# Access Compliance Report Public Rights-of-Way (Curb Ramps)

Intersection ID: 29232      Main Street: ROCKWELL\_BV      Cross Street: ROCKWELL\_BV\_WEST      Location: E

ADA ID: 88AC3EB53E99      Ramp Type: Para      Initial Pass/Fail: Fail      Overall Compliance: No      Severity Score: 18.75

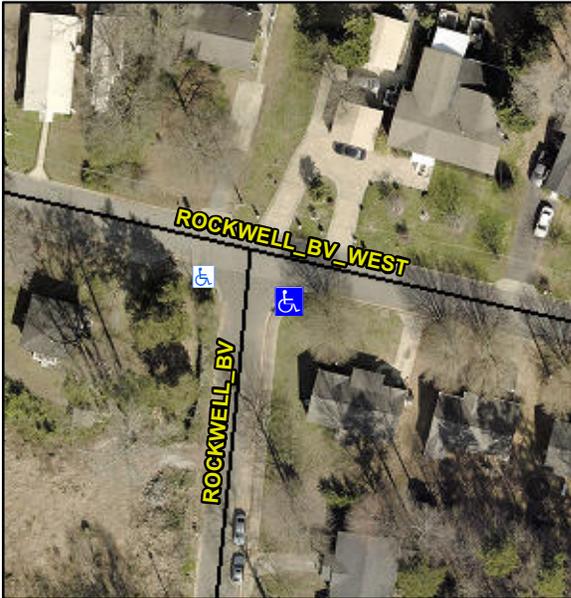
PROW/ADA:  
**R304.5.1, R304.5.3**

Compliance	Description	Data	Compliance	Description	Data
N/A	Ramp Length LT (in)	58.0	N/A	Ramp Length RT (in)	47.0
No	Ramp Width LT (in)	35.0	No	Ramp Width RT (in)	35.0
Yes	Ramp Slope LT (%)	8.2	Yes	Ramp Slope RT (%)	5.1
No	Ramp XSlope LT (%)	5.0	No	Ramp XSlope RT (%)	3.7
N/A	Landing Length (in)	N/A	N/A	DWS Provided?	N/A
N/A	Landing Width (in)	N/A	N/A	DWS Contrast?	N/A
N/A	Landing Slope (%)	N/A	N/A	DWS Length (in)	N/A
N/A	Landing X Slope (%)	N/A	N/A	DWS Full Width?	N/A
N/A	Landing Curb? (Y/N)	N/A	N/A	DWS Offset (in)	N/A
N/A	Shared Landing?	N/A			
N/A	Gutter Ponding?	N/A	N/A	Gutter Slope (%)	N/A
N/A	Gutter Lip Ht (in)	0.5	N/A	Gutter X Slope (%)	N/A
N/A	Painted X Walk1?	No	N/A	Painted X Walk2?	N/A
	X Walk 1 Direction	To W		X Walk 2 Direction	N/A
N/A	X Walk 1 Width (in)	N/A	N/A	X Walk 2 Width (in)	N/A
	X Walk 1 Slope (%)	4.1		X Walk 2 Slope (%)	N/A
	X Walk 1 X Slope (%)	1.8		X Walk 2 X Slope (%)	N/A
N/A	Ramp inside XWalk1?	N/A	N/A	Ramp inside XWalk2?	N/A

Possible Solutions:  
**Remove & Replace Entire Ramp.**
